The Calcutta Gazette

WEDNESDAY, MAY 31, 1922.

NOTICES TO MARINERS.

The following Notices are republished for general information.

Reproduction of Portion of Chart N° 758.

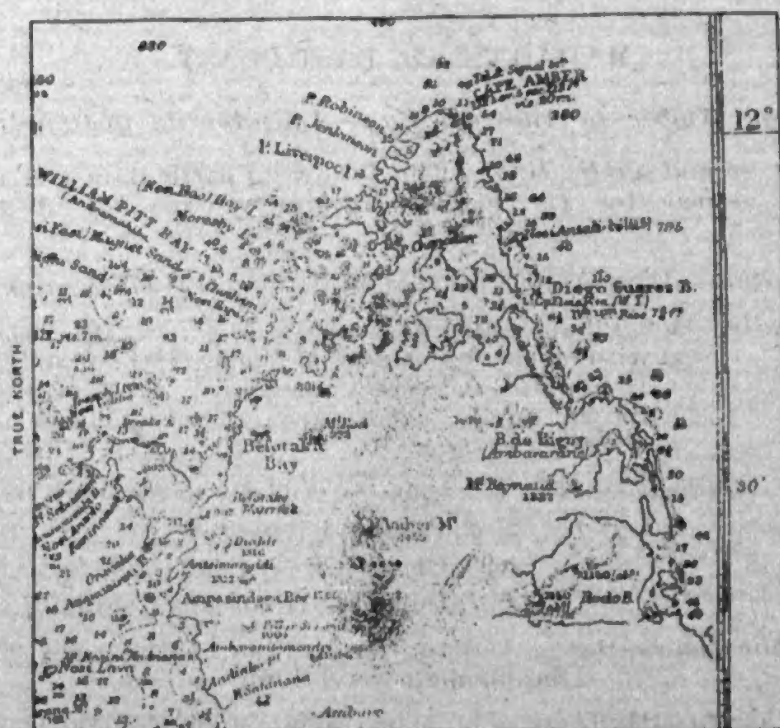
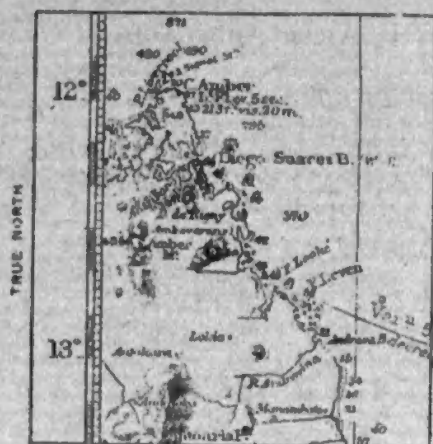
Details.—General amendments to charts Nos. 758, 2762, 2899 and 597 with regard to the coast of Madagascar and offlying shoals and depths, between Cape Amber and Andrava bay, are shown on the accompanying reproductions of portions of those charts.

Reproduction of Portion of Chart No. 648.

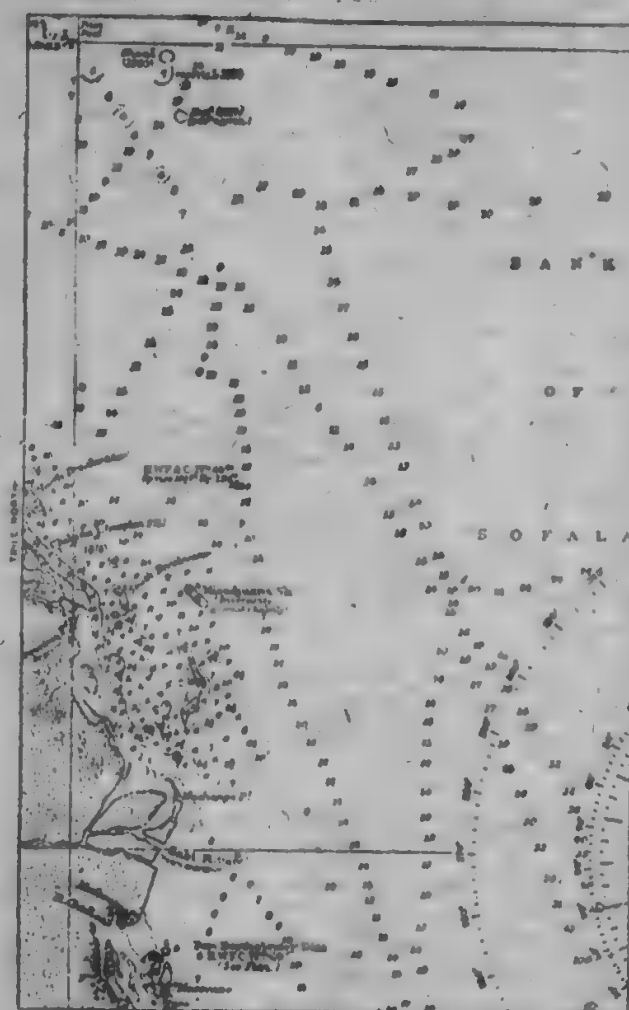
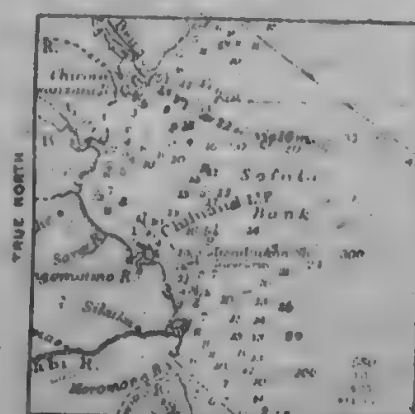
Details.—Additional depths in the southern approach to Beira are shown on the accompanying reproductions of portions of charts Nos. 648 and 597.

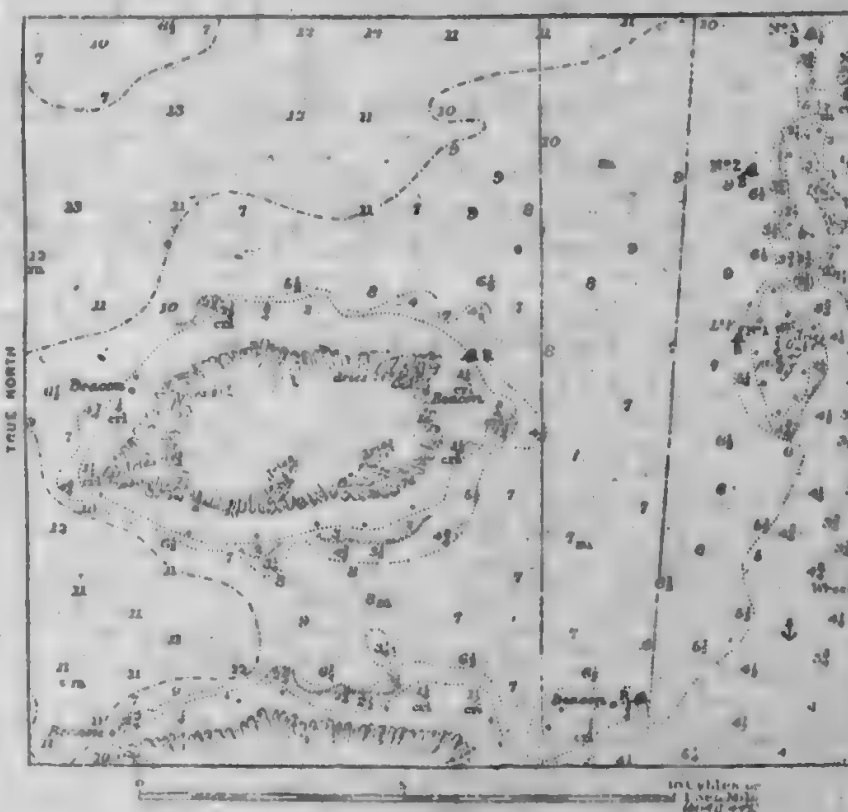
Details.—1. Extensive alterations in the buoyage and beaconage of Jibuti bay and approaches are shown on the accompanying reproduction of portions of chart No. 253. The buoy formerly marking Météore reef, which is omitted from the reproduction, has been withdrawn.

2. The buoys formerly marking Penguin and Etoile banks also the white can buoy formerly marking the shore bank northward of Plateau du Héron have been withdrawn and are to be expunged from the charts.
3. The black can buoy situated about 2½ miles westward of Mashah lighthouse has been replaced by a black bell buoy.

Reproduction of Portion of Chart No 758.

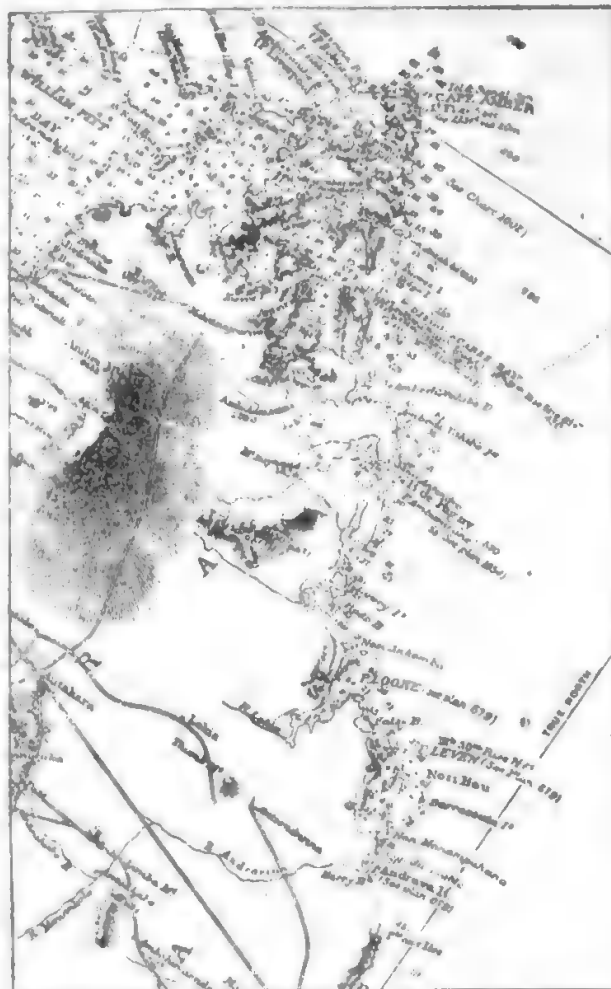
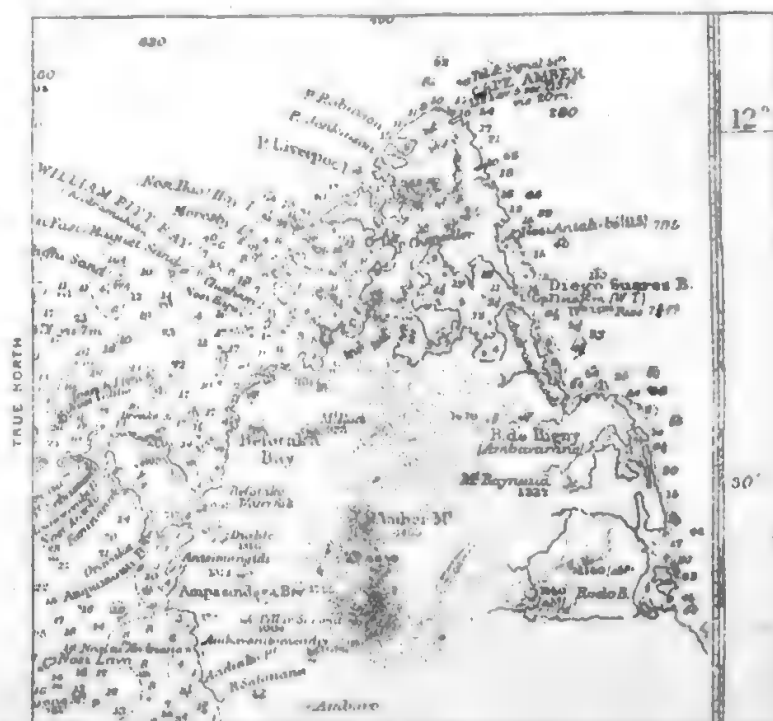
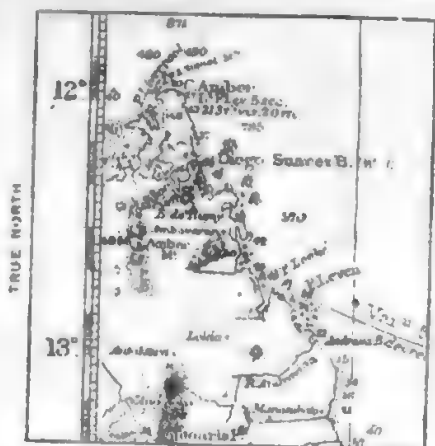
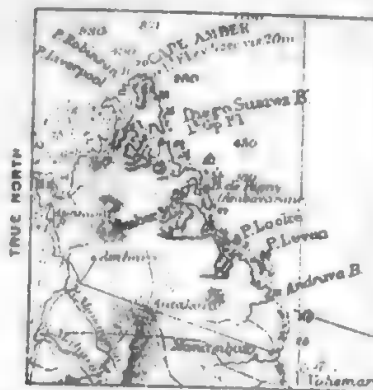
Details.—General amendments to charts Nos. 758, 2762, 2899 and 597 with regard to the coast of Madagascar and offlying shoals and depths, between Cape Amber and Andrava bay, are shown on the accompanying reproductions of portions of those charts.

Reproduction of Portion of Chart No. 648.

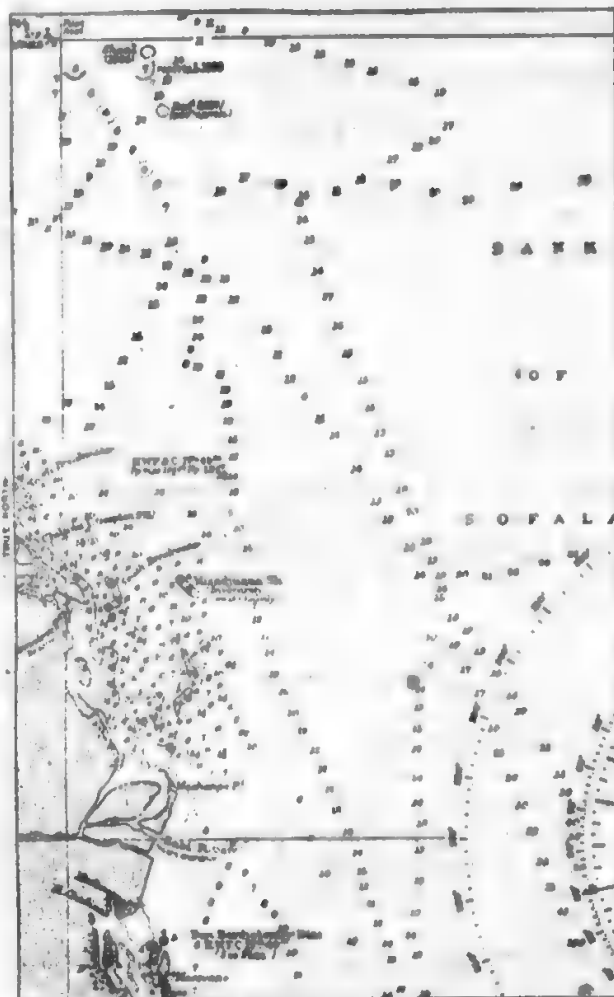
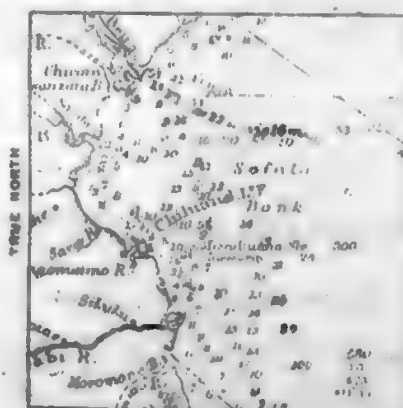
Details.—Additional depths in the southern approach to Beira are shown on the accompanying reproductions of portions of charts Nos. 648 and 597.

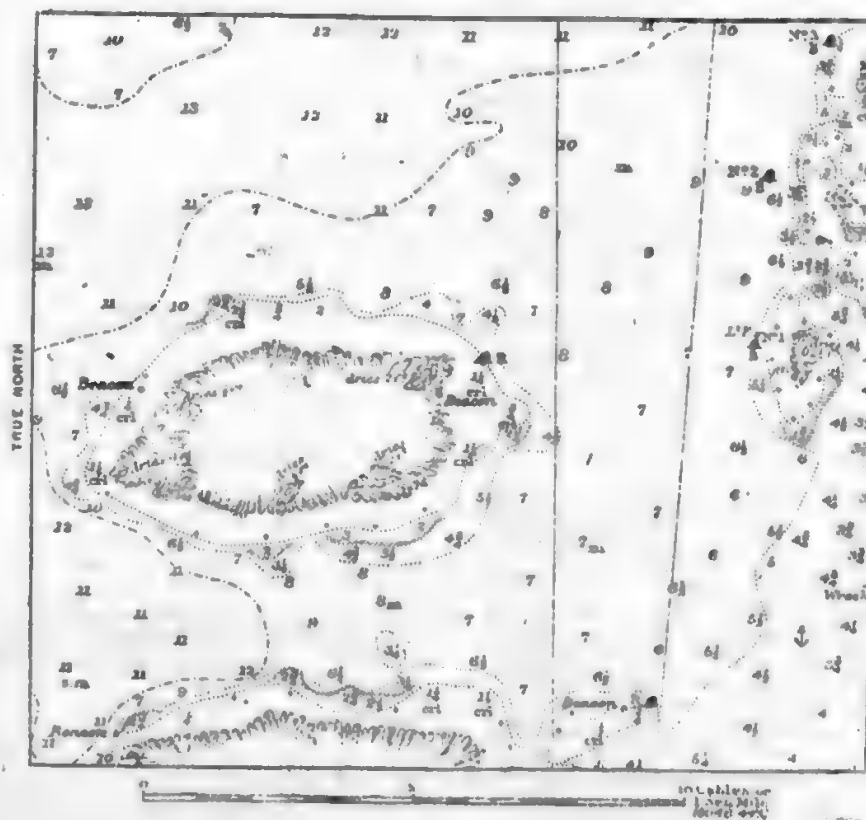
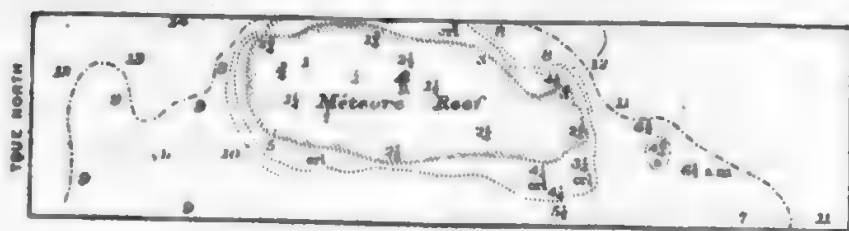
Details.—1. Extensive alterations in the buoyage and beaconage of Jibuti bay and approaches are shown on the accompanying reproduction of portions of chart No. 253. The buoy formerly marking Météore reef, which is omitted from the reproduction, has been withdrawn.

2. The buoys formerly marking Penguin and Etoile banks also the white can buoy formerly marking the shore bank northward of Plateau du Héron have been withdrawn and are to be expunged from the charts.
3. The black can buoy situated about 2½ miles westward of Mashah lighthouse has been replaced by a black bell buoy.

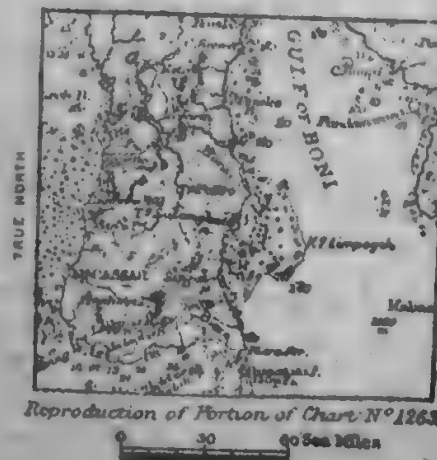
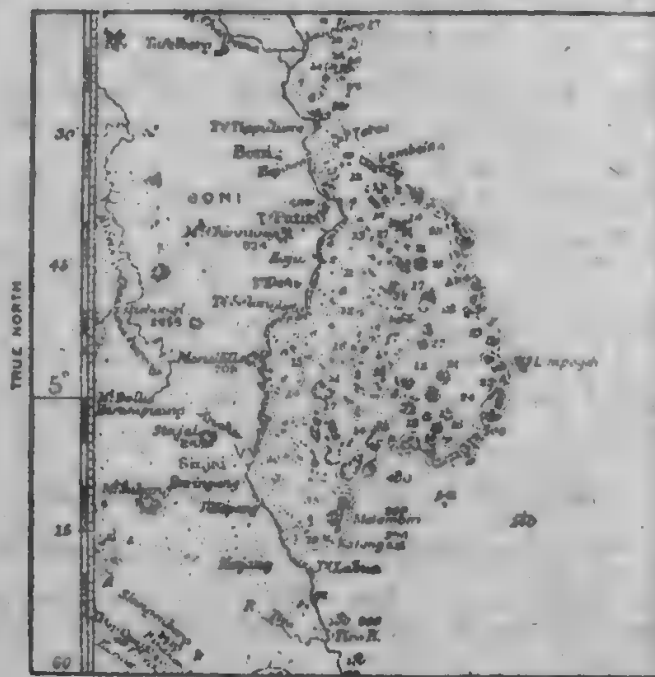
Details.—The accompanying reproductions of portions of charts Nos. 3616, 941b, 942a, 2759a, and 1263, show extensive amendments and corrections with regard to off-lying shoals and depths, etc., between Boni and Tanjong Bua.

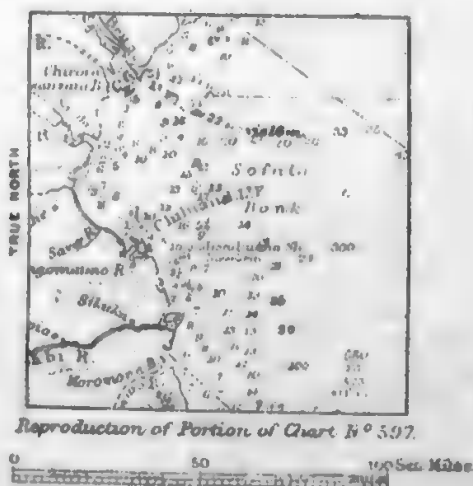
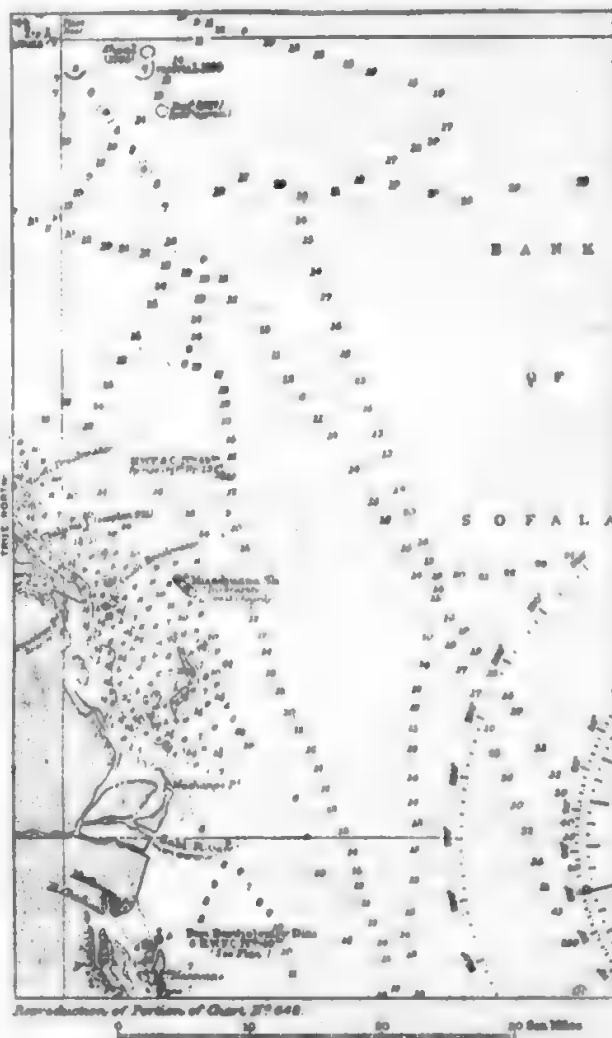
Details.—Additional depths in the southern approach to Beira are shown on the accompanying reproductions of portions of charts Nos. 648 and 597.

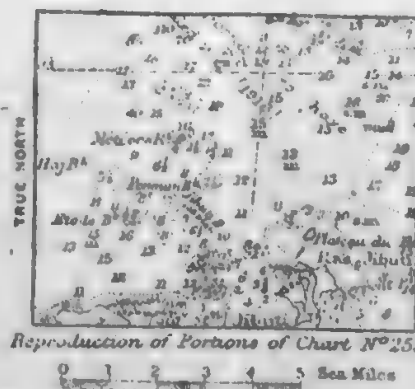
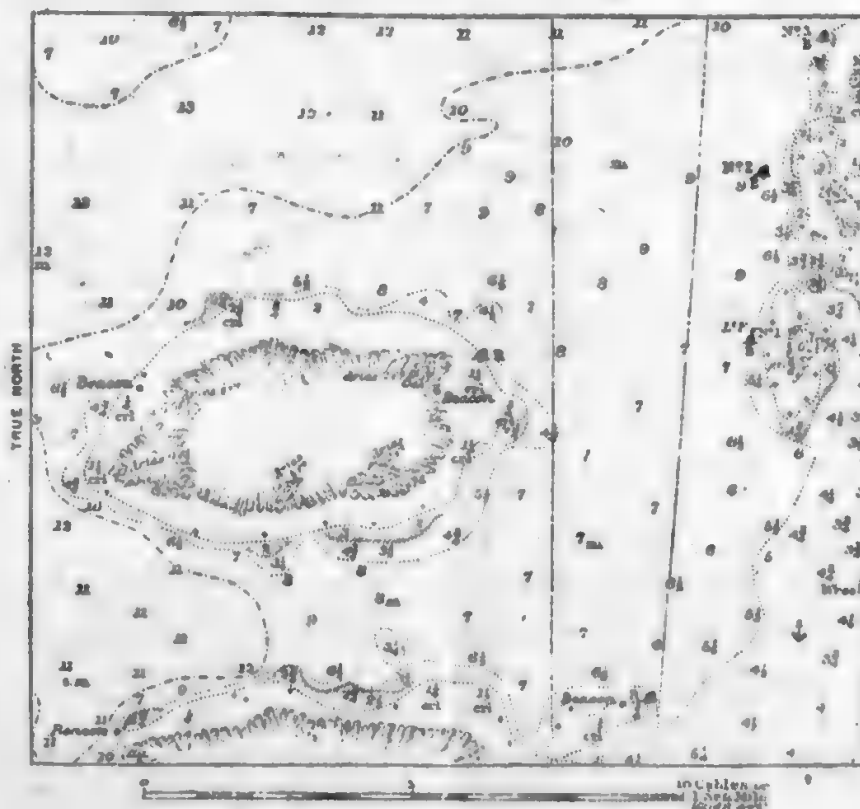
Details.—1. Extensive alterations in the buoyage and beaconage of Jibuti bay and approaches are shown on the accompanying reproduction of portions of chart No. 253. The buoy formerly marking Météore reef, which is omitted from the reproduction, has been withdrawn.

2. The buoys formerly marking Penguin and Etoile banks also the white can buoy formerly marking the shore bank northward of Plateau du Héron have been withdrawn and are to be expunged from the charts.
3. The black can buoy situated about 2½ miles westward of Mashah lighthouse has been replaced by a black bell buoy.

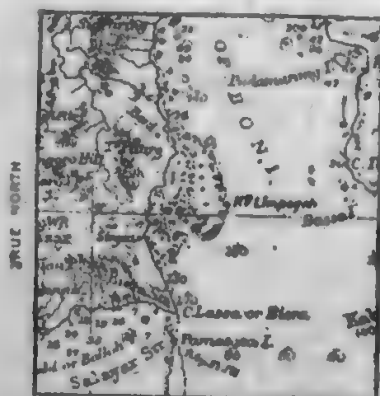
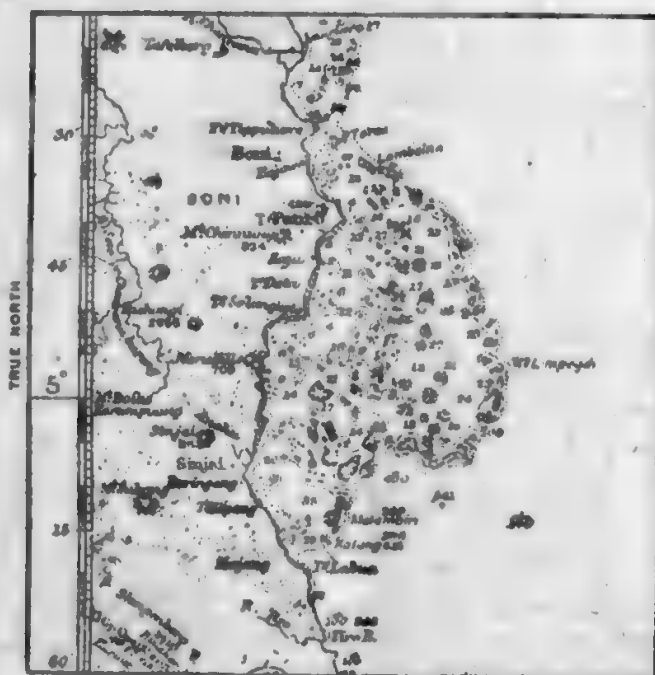
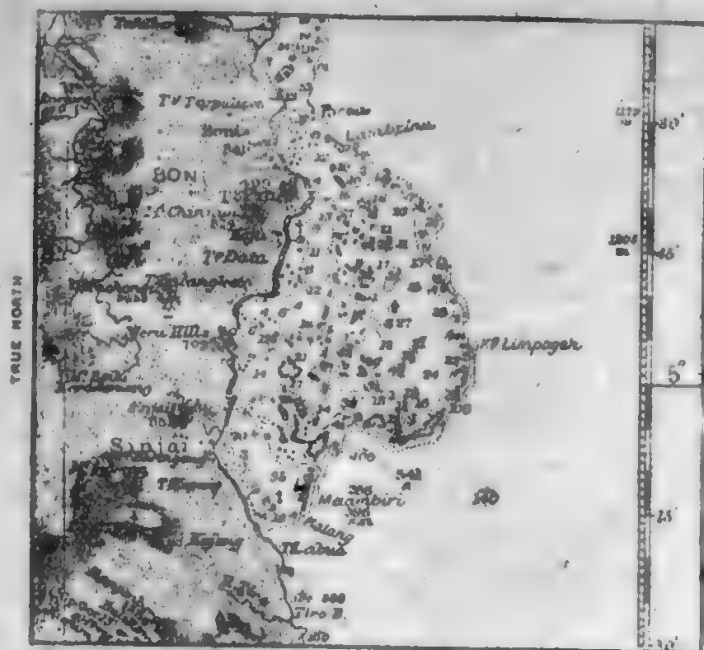
Details.—The accompanying reproductions of portions of charts Nos. 3616, 941b, 942a, 2759a, and 1263, show extensive amendments and corrections with regard to off-lying shoals and depths, etc., between Boni and Tanjong Bua.

Reproduction of Portion of Chart N° 2760.

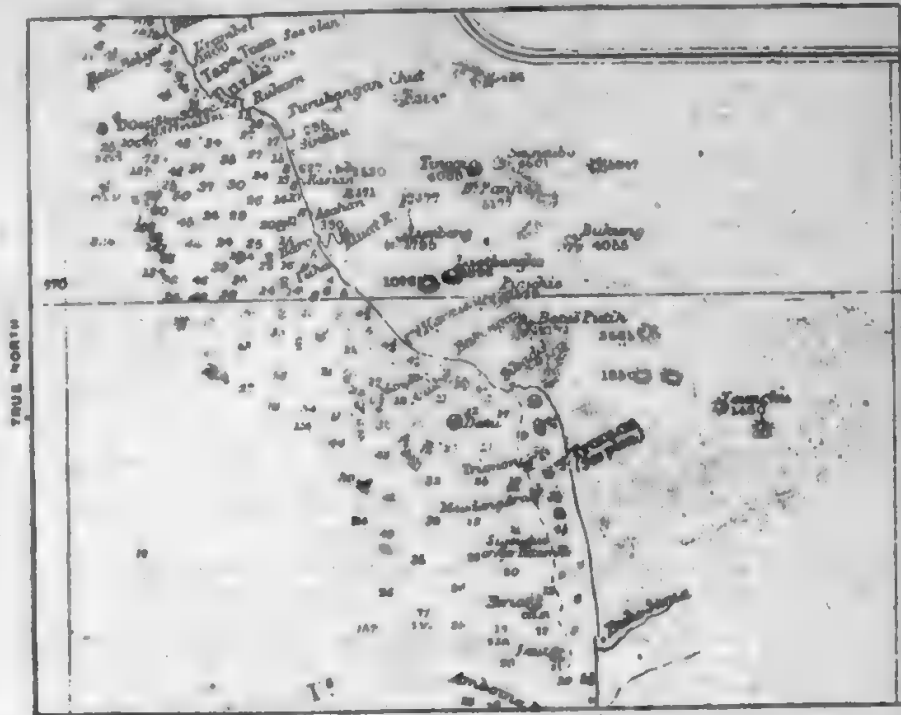
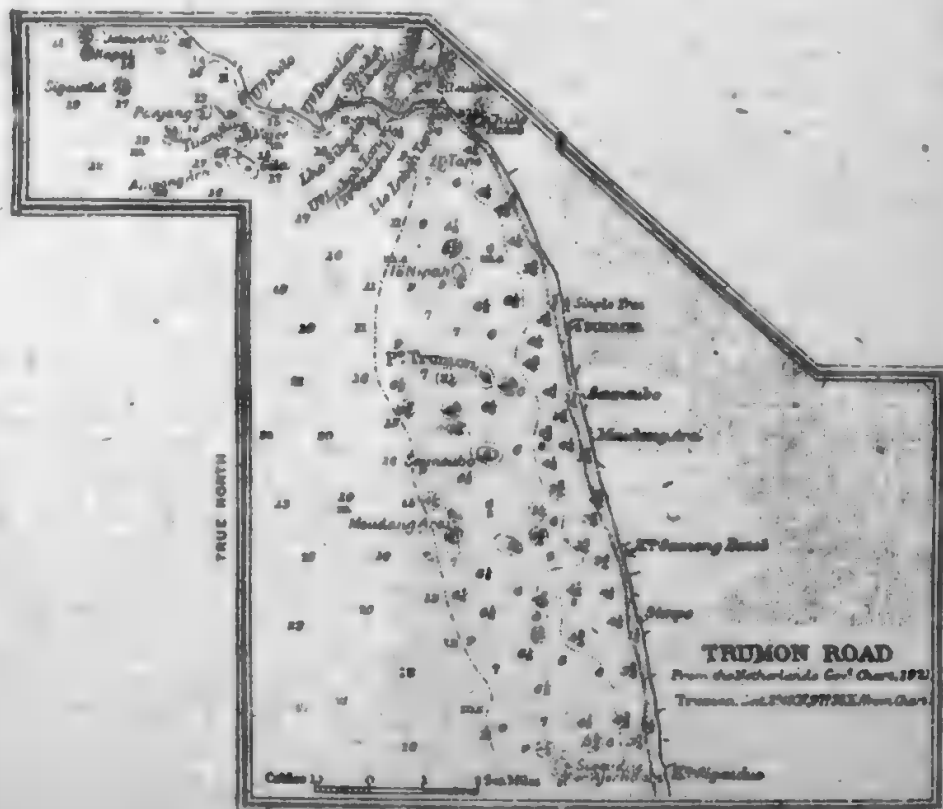
Details.—The accompanying reproductions of a portion of chart No. 2760, and of the inset plan of Trumon road, show general amendments to that chart in the vicinity of Trumon.
